**Bid No. 7449616**

**Plans & Specifications for  
Site improvements  
&  
New Salt Storage Building**

**Dillon's Corner Salt Storage Facility  
Town of Narragansett, Rhode Island**

**ADDENDUM NO. 1**

REVISION NO. 1      4/19/2012  
 RIDOT DIVISION OF HIGHWAY  
 AND BRIDGE MAINTENANCE  
 PROPOSED SALT SHED BUILDING  
 DILLON'S CORNER FACILITY  
 SCHEMATIC DIAGRAM

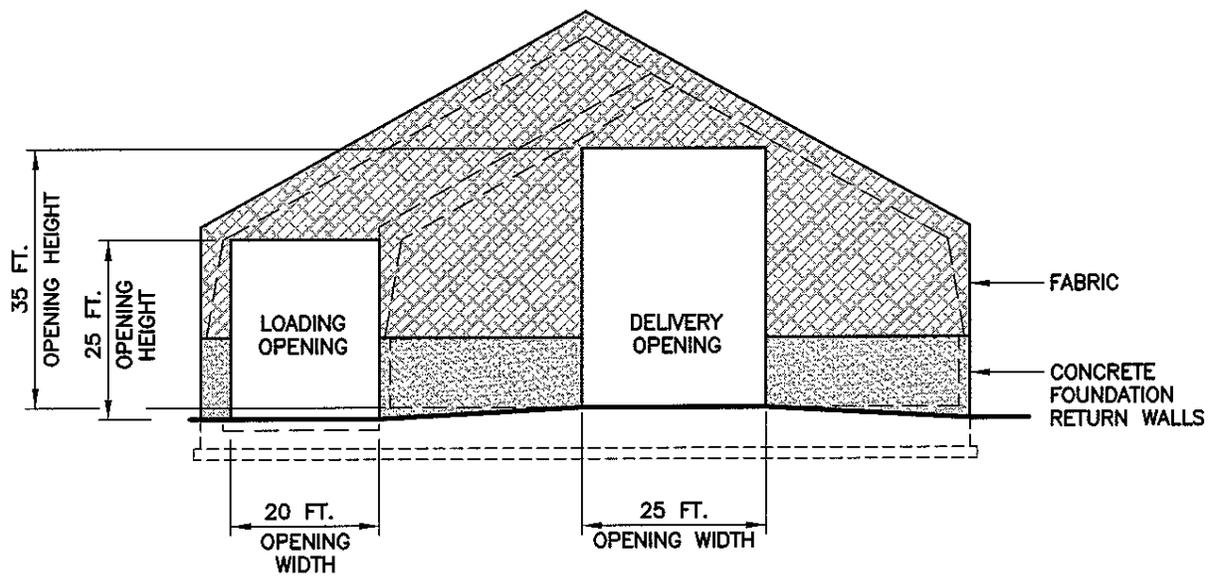
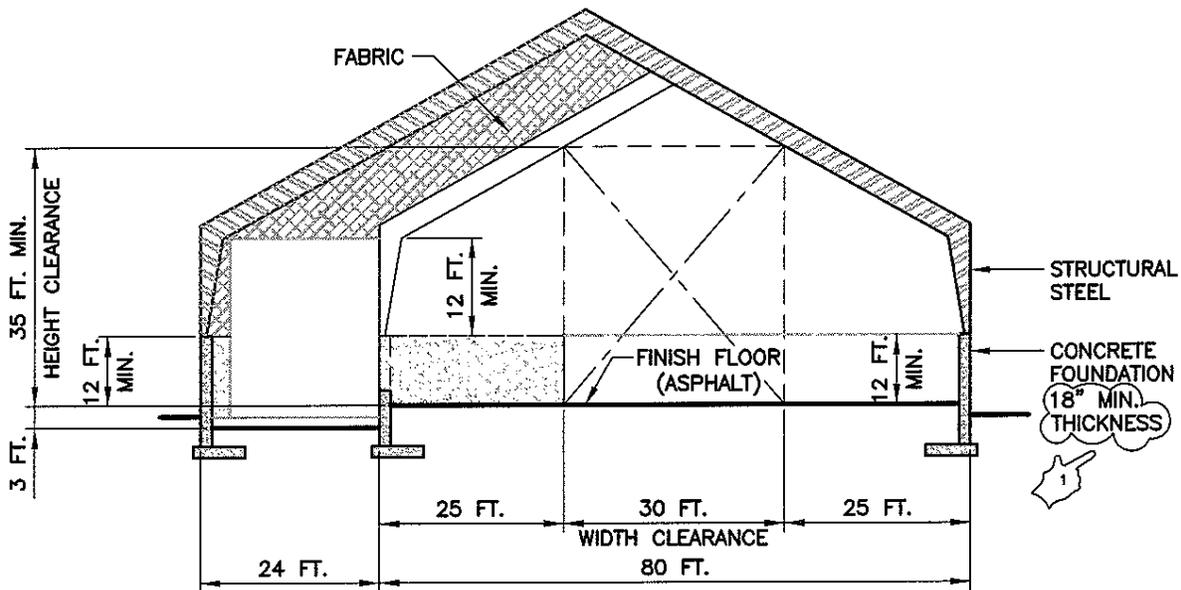
The Schematic Diagram depicting the typical cross section of the salt storage building has been revised. The Revised diagram is attached as a PDF. Revisions are clouded and marked Rev.1.
